# SERVICE BULLETIN

No. 68-9-4

INCORRECT  
OIL  
LEVEL  
INDICATOR

1968  
BELVEDERE  
MODELS  
EQUIPPED  
WITH  
C.I.D.  
HEMI  
ENGINE

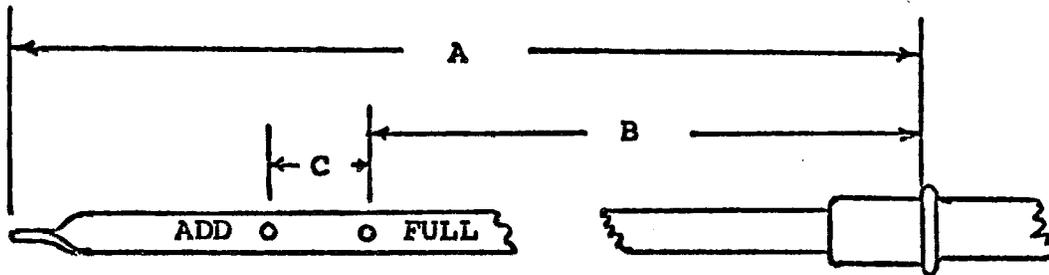
It has been determined that the 1967 oil level indicator, Part No. 2806238, was used in the 1968 engines through 12-1-67. This indicator would show one quart overflow when six quarts of oil is used.

Part No. 2951255 is the correct oil level indicator for the 1968 426 Hemi. The identification and dimensions of this indicator are shown below. Please replace all indicators (dipsticks) that do not correspond.

The indicator insulator should be transferred from the original indicator, to the new indicator, or a new insulator, Part No. 2806239 should be installed, at the time of indicator replacement.

PART NO.	A	B	C	HANDLE IDENTIFICATION
2946006	20.00	17.63	.43	ORANGE INK
